AMENDMENT NO. 0012 TO ADVERTISED RFP DACW31-03-R-0003
EFFECTIVE MAY 09, 2003

<p>STADIUM IMPROVEMENTS ANACOSTIA SENIOR HIGH SCHOOL</p> <p>BRYANT ASSOCIATES, PC - ARCHITECTS 1420 N. ST. NW. WASHINGTON D.C. 20005</p>	<p>CIVIL ENGINEERS: EDTS, Inc. M/E/P ENGINEERS: George Worsley & Assoc. COST ESTIMATORS: S.C. Meyers & Assoc. LAND SURVEYOR: Vyfhuis & Assoc.</p>	<p>DATE: 4-11-03 REV: 4-28-03</p> <p>ISSUED VIA:</p>	<p>SK - S</p> <p>1</p> <p>DWG REF:</p>
---	--	---	--

1 RETAINING WALL DET.
 S9 | S9 SCALE: N.T.S

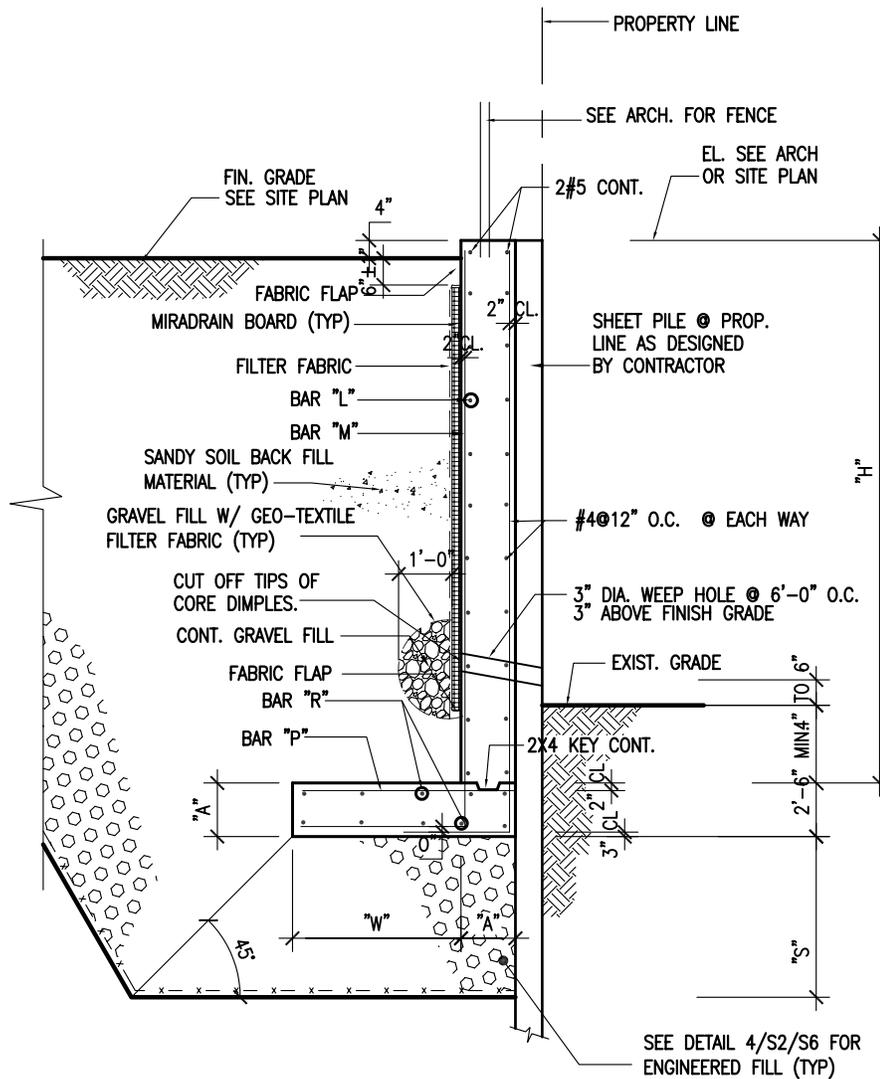
- 1) Amendment 0009, Item 2: Delete Sketch SK-S1 and substitute the attached revised like-numbered sketch, dated 4/28/03.

ATTACHMENTS: Revised Sketch SK-S-1, dated 4/28/03.
